## **Metro South-West Joint Development Assessment Panel Agenda**

**Meeting Date and Time:** Thursday, 4 February 2016; 1:00pm  
**Meeting Number:** MSWJDAP/92  
**Meeting Venue:** City of Rockingham

Property Location:	Lot 159 Minden Lane, Baldivis
Application Details:	Mixed Use Development (Showroom and Office)
Applicant:	Planning 4Site Pty Ltd (MW Urban)
Owner:	Staub Family Pty Ltd
Responsible authority:	City of Rockingham
DoP File No:	DAP/14/00631

<b>Property Location:</b>	Lot 159 Minden Lane, Baldivis
<b>Application Details:</b>	Mixed Use Development (Showroom and Office)
<b>DAP Name:</b>	Metro South West JDAP
<b>Applicant:</b>	Planning 4Site Pty Ltd (MW Urban)
<b>Owner:</b>	Staub Family Pty Ltd
<b>LG Reference:</b>	20.2014.373.001 (D15/172990)
<b>Responsible Authority:</b>	City of Rockingham
<b>Authorising Officer:</b>	Mr Bob Jeans, Director Planning & Development Services
<b>Department of Planning File No:</b>	DAP/14/00631
<b>Report Date:</b>	21 December 2015
<b>Application Receipt Date:</b>	19 September 2014
<b>Application Process Days:</b>	60
<b>Attachment(s):</b>	<ol style="list-style-type: none"><li>1. JDAP Refusal</li><li>2. Second JDAP deferral</li><li>3. First JDAP

Figure 3 – Revised (Current) Site and Ground Floor Plan (11.12.2015)

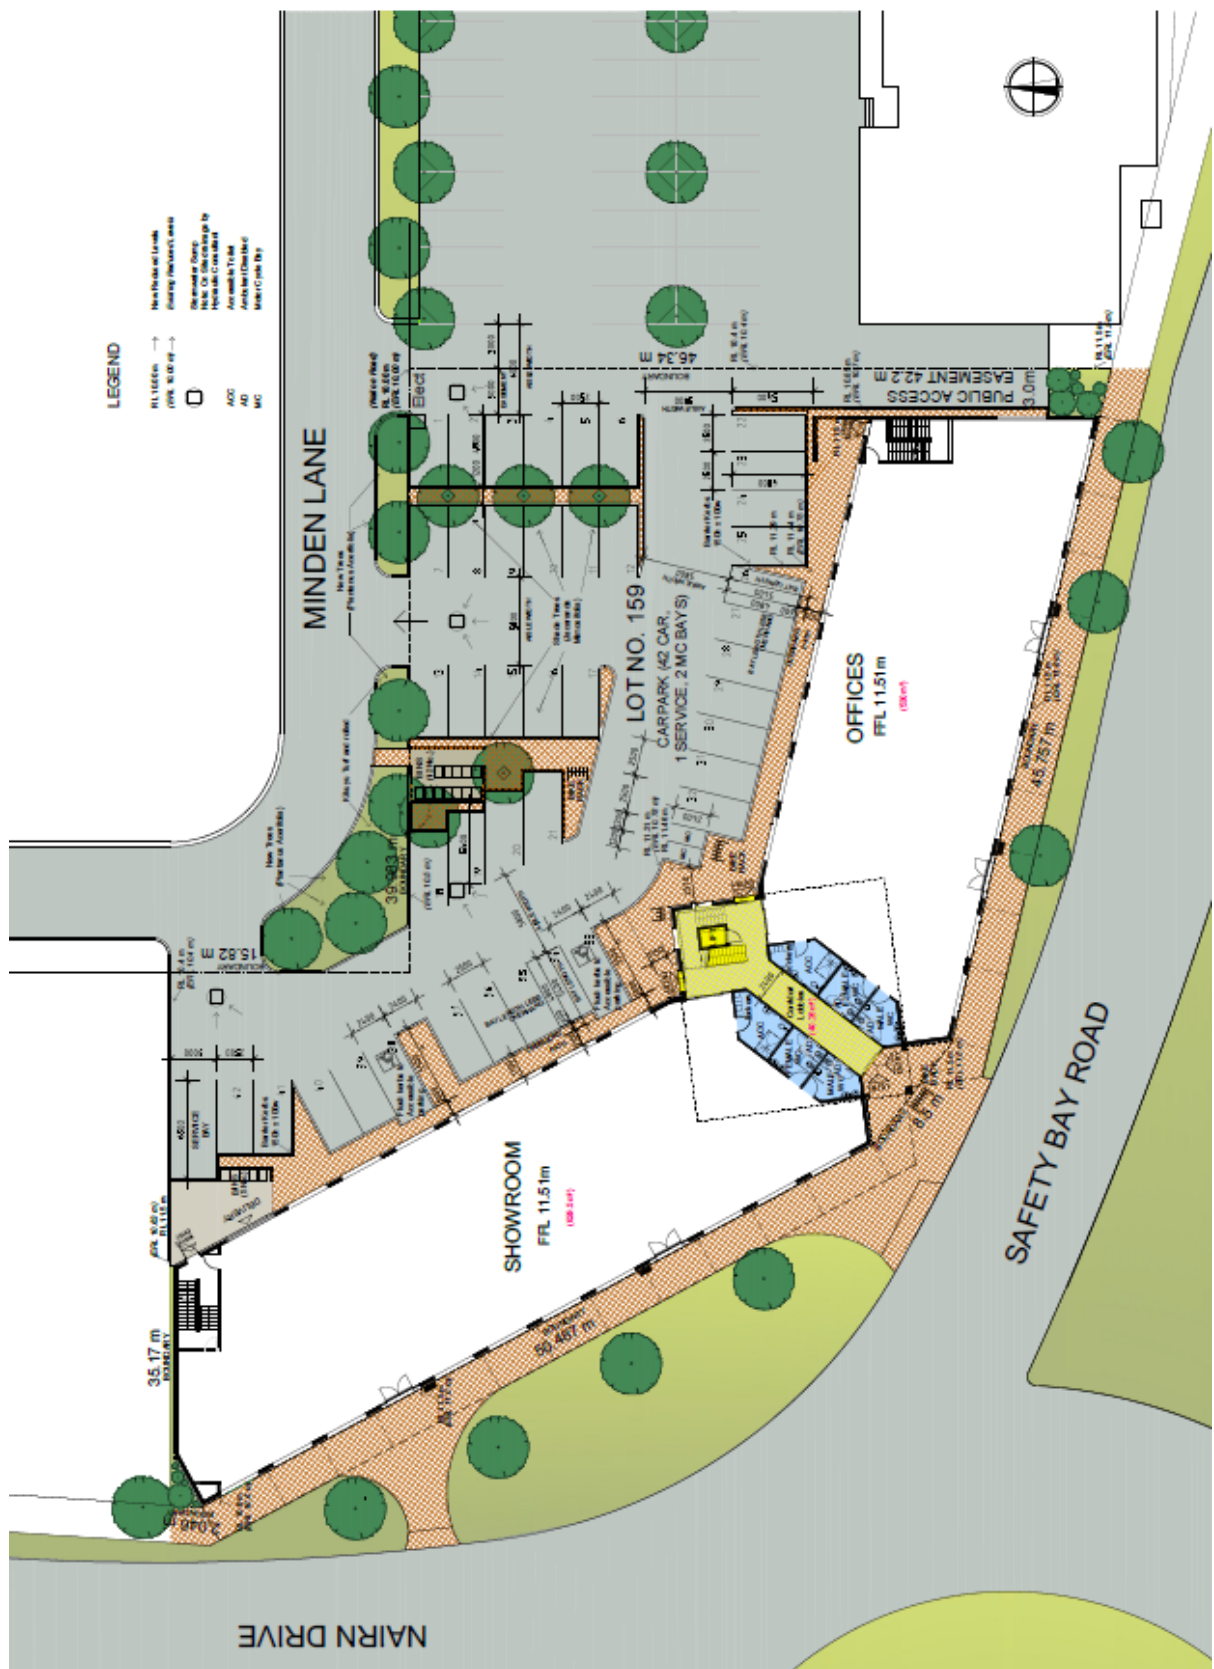
- (a) The proposed development fails to provide an adequately designed car park, as it does not comply with the parking requirements of *AS/NZS 2890.1:2004 Parking facilities - Off-street car parking*.

- (c) Adequate provision has not been made for the loading and unloading of service vehicles, as required by Clause 67(s) of the *Planning and Development (Local Planning Schemes) Regulations 2015 (Schedule 2 - Deemed Provisions)*.

- Under AS/NZS2890.1 the development is assigned User Class 3, being 'Short-term town centre parking'. For car parking bays at 90° the following is required:
  - A parking bay width of 2.6m must be provided. The proposal provides for bays widths of 2.5m. No bays comply with this width; and
  - An aisle width of 5.8m is required. The development does not achieve this minimum width in the North Western corner of the lot. Furthermore, in order to provide the required bay widths of 2.6, the aisle widths will have to be reduced below the required 5.8m. The development cannot provide the required bay width and aisle width without modifying the building design

Figure 6 – Revised (Current) Safety Bay Road Elevation (South Western) (8.6.2015)

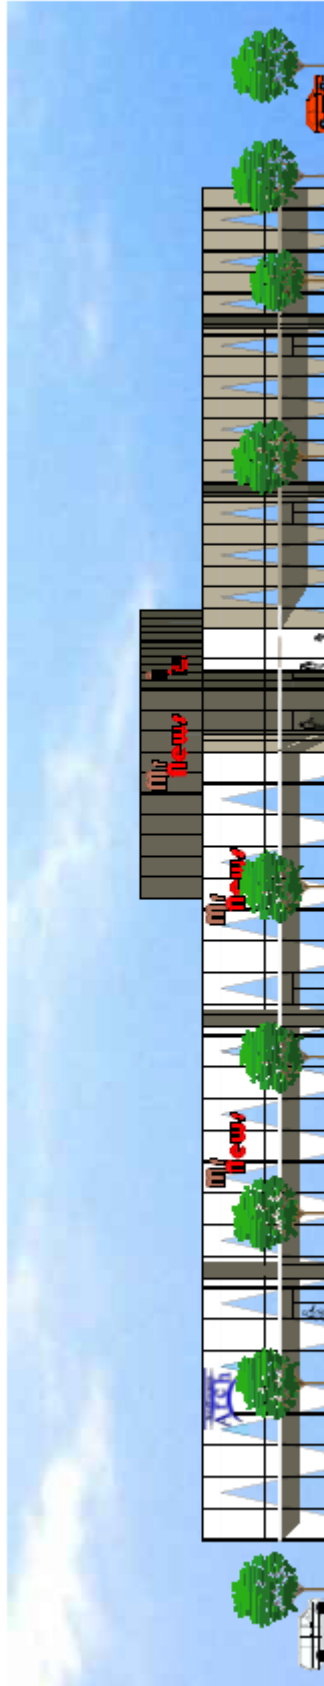
- (d) The proposed development does not provide sufficient variety and articulation of street front building facades as required by clause 7.4.3 (iv) of the City's Local Planning Policy 3.2.4 – Baldivis Town Centre.

- (g) The street elevations are not articulated to include defined street front entries which are clearly identifiable from the street as is required by clause 8.1.3 (v) of the City's Local Planning Policy 3.2.4 – Baldivis Town Centre.

- (j) The ground level facades fronting the street provides for less than 60% transparency as required by clause 4 (g) of the approved Detailed Area Plan.
- (k) Primary entry to ground floor tenancies is accessed via the pedestrian corridors contrary to clause 5 (b) of the approved Detailed Area Plan.
- (l) Variety and high urban design standards have not been incorporated into the design contrary to clause 6 (a) of the approved Detailed Area Plan.
- (m) Delivery, loading and storage areas are visible from public view contrary to clause 7 (a) of the approved Detailed Area Plan.
- (n) A showroom is not identified as a preferred land use for the Core precinct under the Baldivis Activity Centre Structure Plan.

SAFETY BAY ROAD ELEVATION  
1:200

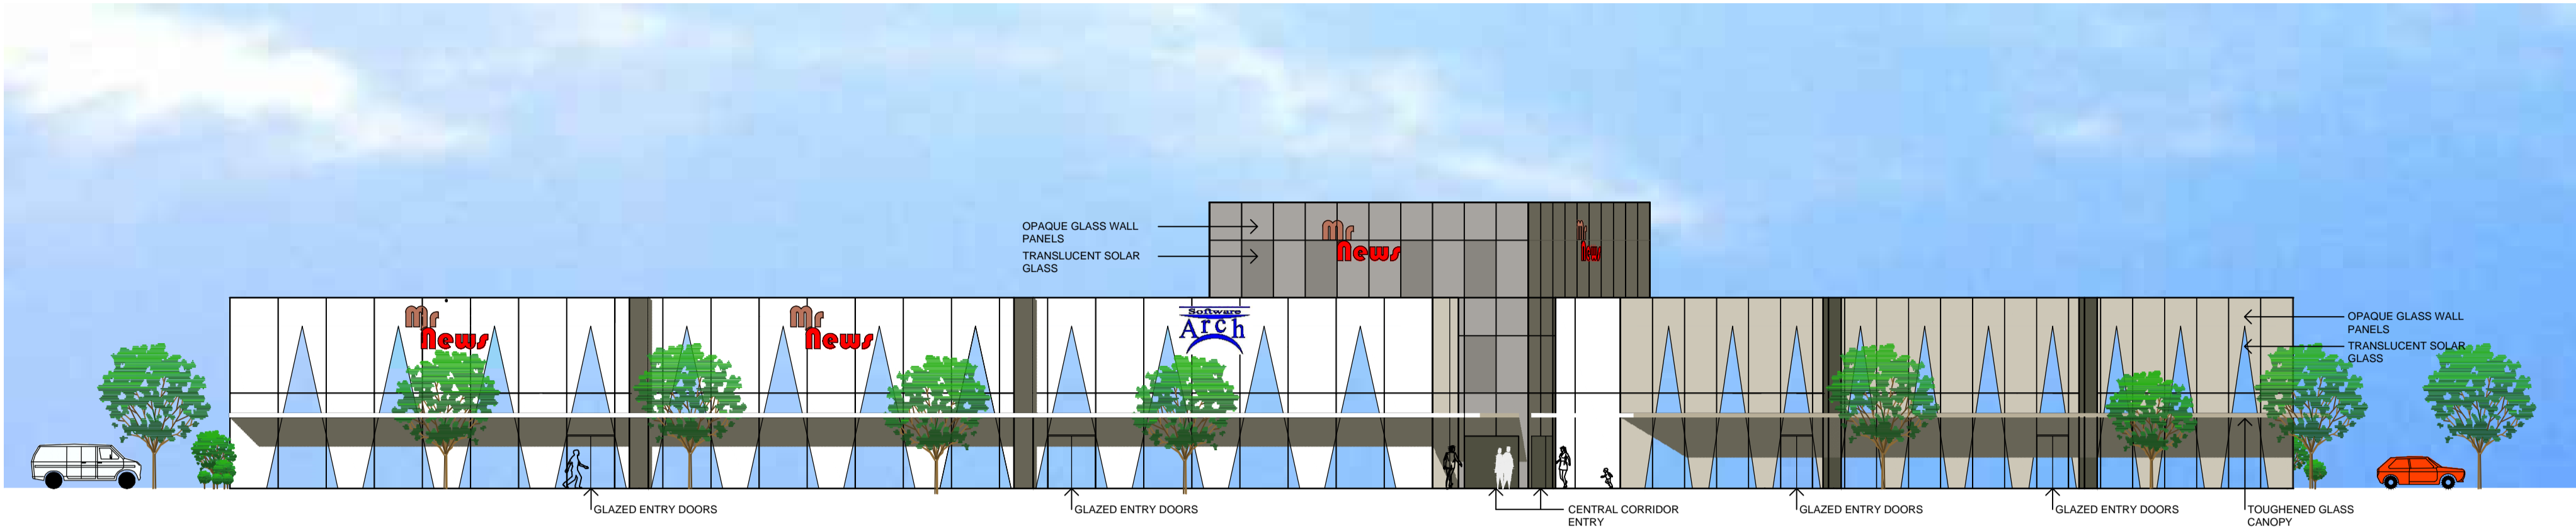
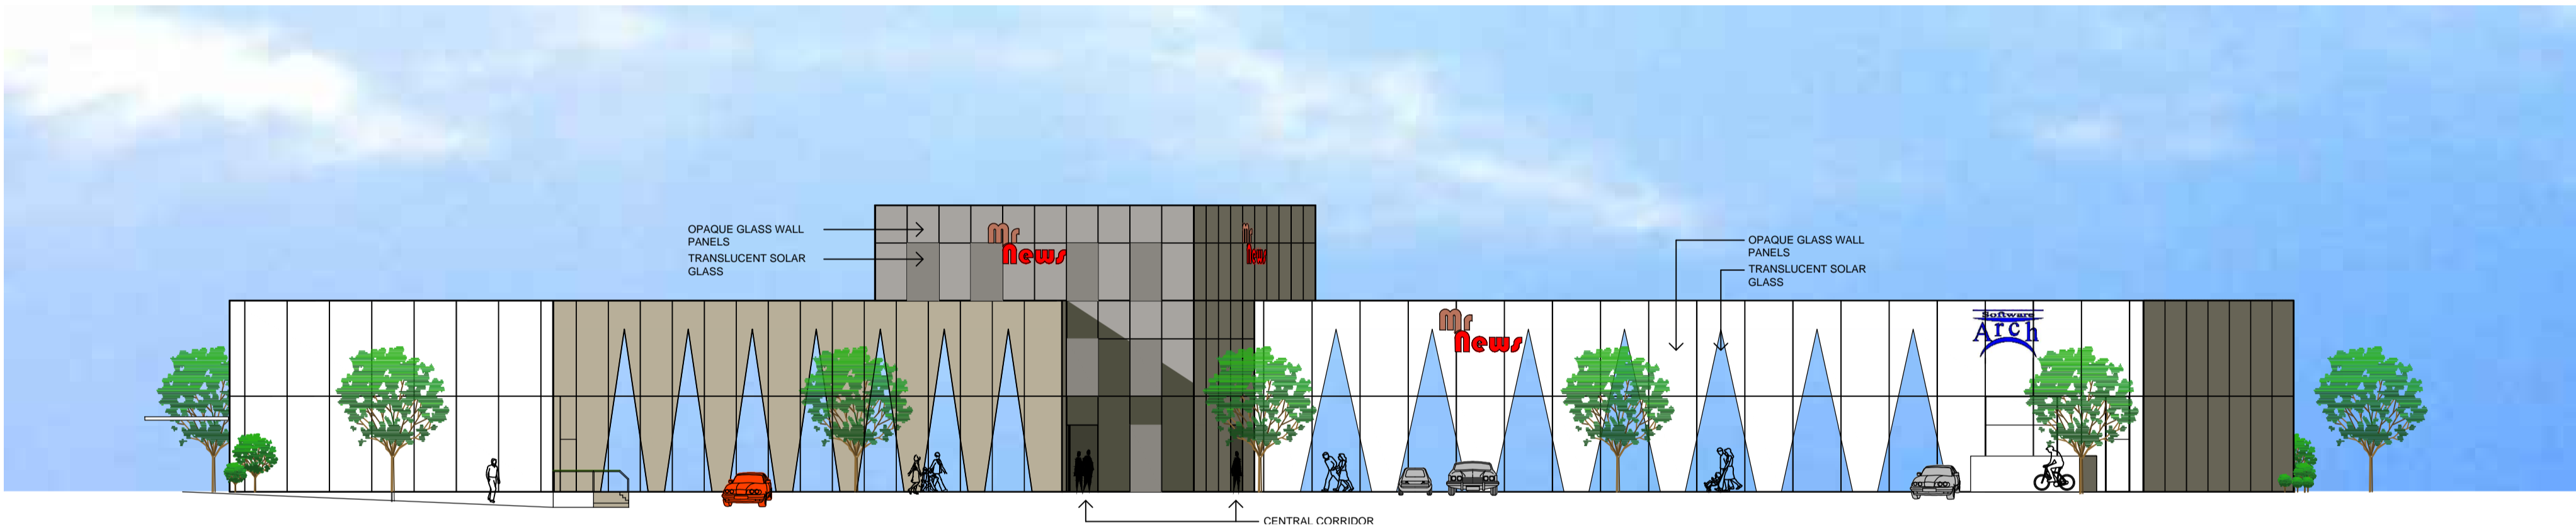
- (h) The proposal lacks variety and high design standards as required by clause 8.1.3 (ix) of the City's Local Planning Policy 3.2.4 – Baldivis Town Centre.
